Long-Term Groundwater
Monitoring Optimization
Clare Water Supply Superfund Site
StageRight Area
Clare, Michigan

EPA 542-R-07-009
August 2007
www.epa.gov

RESPONSE TO MDEQ COMMENTS ON THE DRAFT LONG-TERM GROUNDWATER MONITORING OPTIMIZATION CLARE WATER SUPPLY SUPERFUND SITE

GSI Job No.	G-3138-105	Drawn by:	MV
Issued:	03/22/2007	Chk'd by:	MV
Figure 1		Appv'd by:	MV

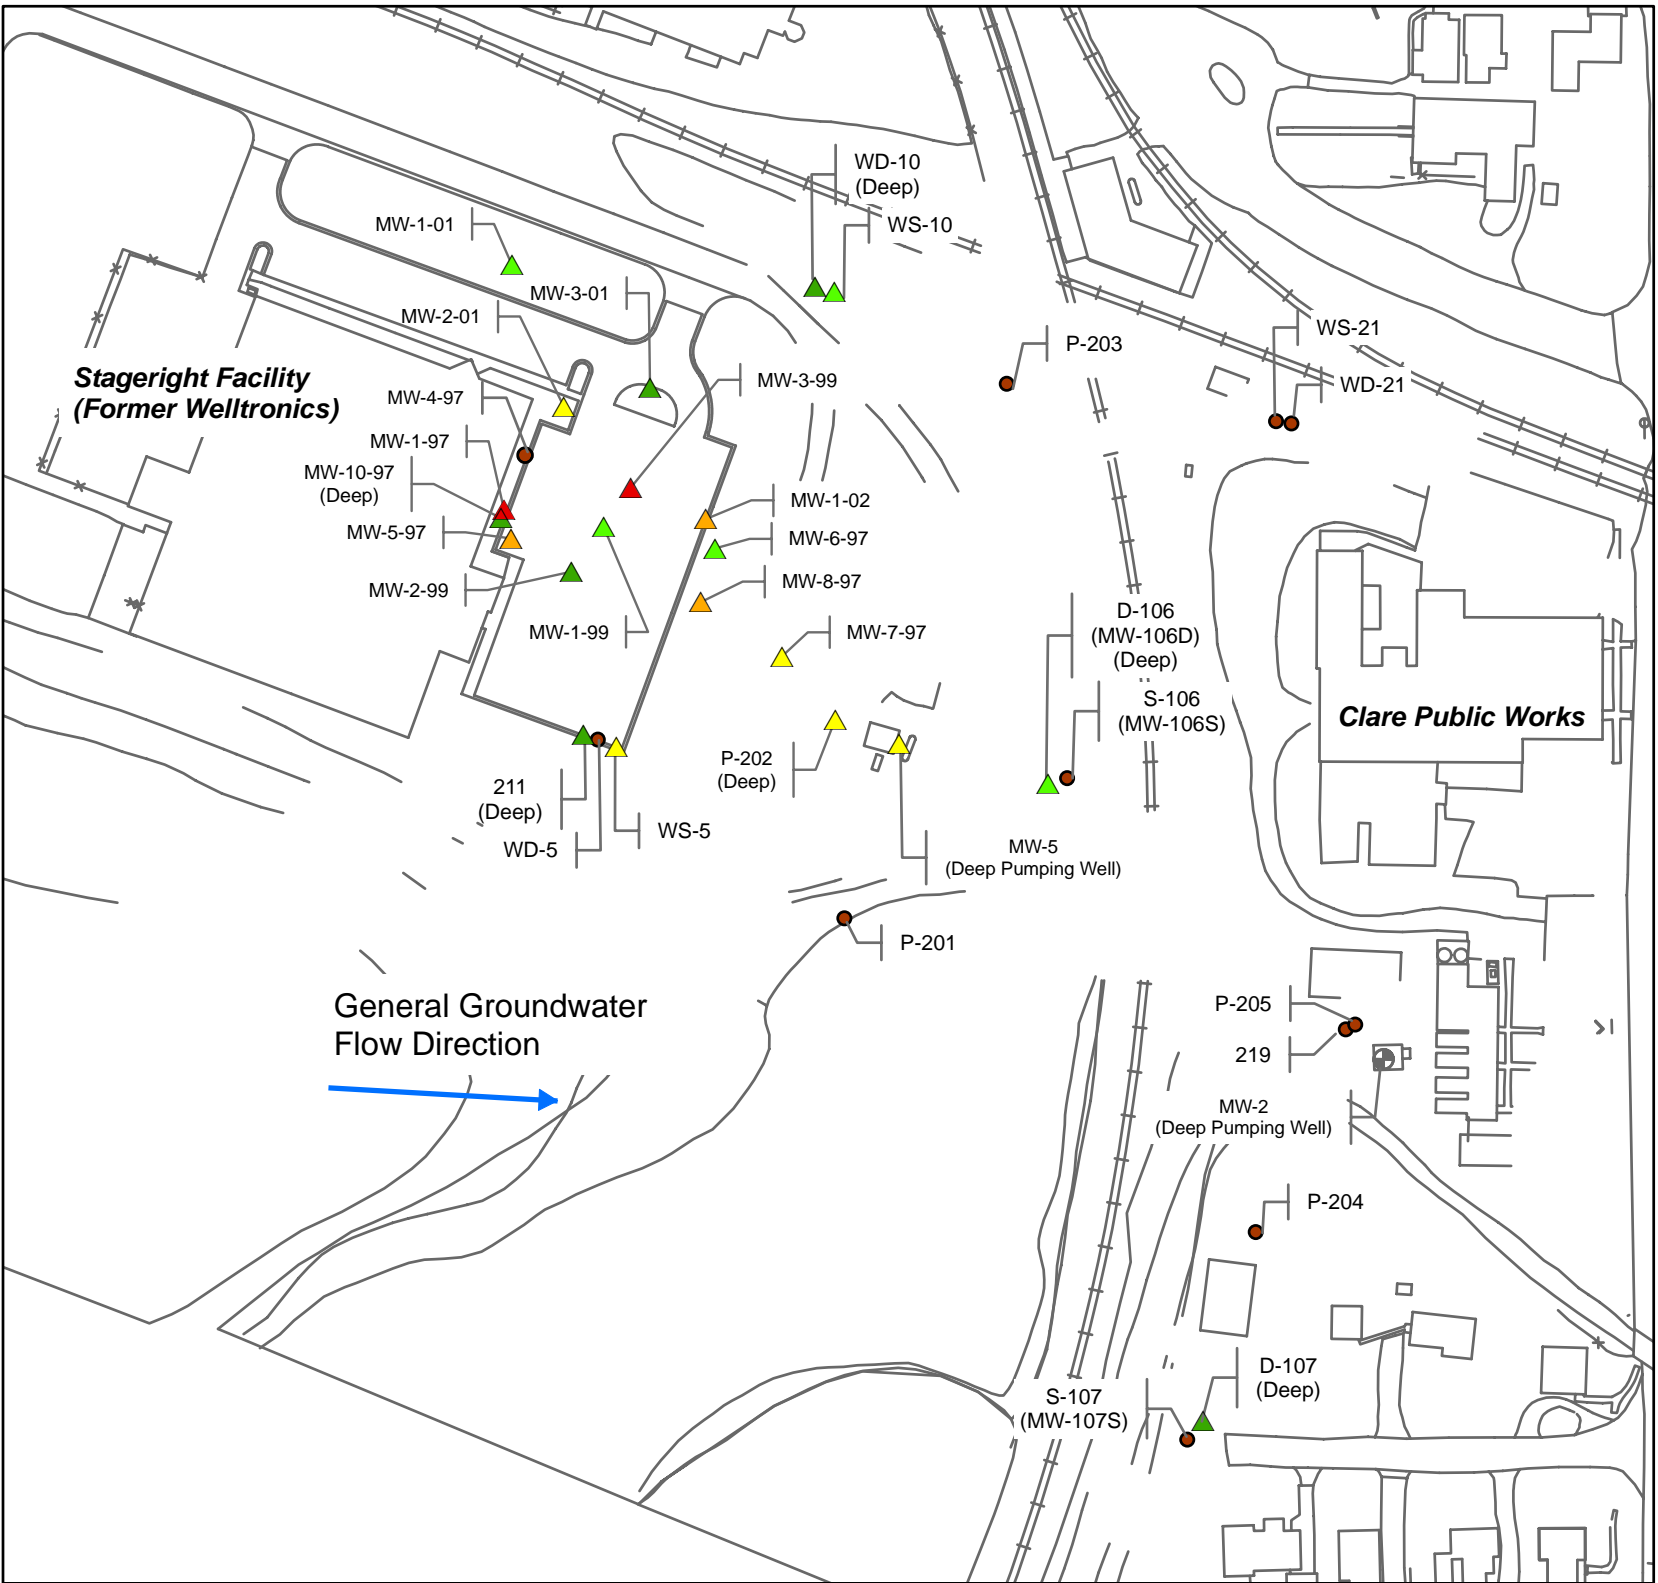
<p>JS Comment 2j and 3a</p>			<p>The new municipal well, MW-8, was not mentioned. It should be noted on the site maps, and considered in the LTMO evaluation. Even though this well is outside the StageRight area, it is a potential receptor of contaminants from StageRight. Because of this, it should be considered in the evaluation.</p>	<p>The new municipal well was installed as we finished the draft report. The authors were not informed of its construction until after the analysis was performed.</p> <p>We do not have the coordinates for the well or any information on its screened interval, pumping rate or preliminary concentrations of priority COCs. Because this well was installed near an existing contaminant plume, it should be sampled periodically same as other nearby active water supply wells.</p>
<p>BV Comment 1 (page 1,</p>	<p>Stageright</p>	<p>General</p>	<p>There is no site conceptual model presented to provide the basis for the optimization effort. Were the remedial design MODFLOW files used for this project? Since they</p>	<p>As far as the authors know, there is no single document describing a consensus site conceptual model for the areas of concern. (For further discussion of site conceptual model and site</p>
